# Service Action Code: 37M9

#### **Exhaust Bracket**

February 04, 2021

Country	Beginning Model Year	Ending Model Year	Vehicle	Vehicle Count
USA	2021	2021	RS6 AVANT	20
USA	2021	2021	RS7	24

#### Remove subframe shield upper section:

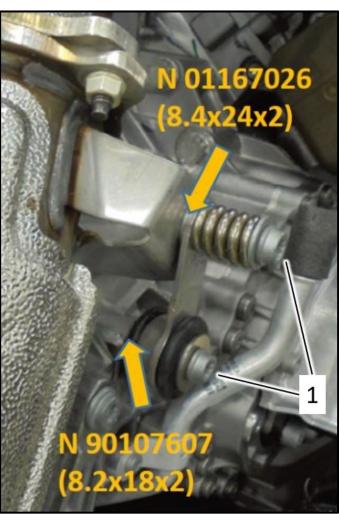
- Remove the screws <A and B arrows>.
- Remove upper section of the shield <1>.
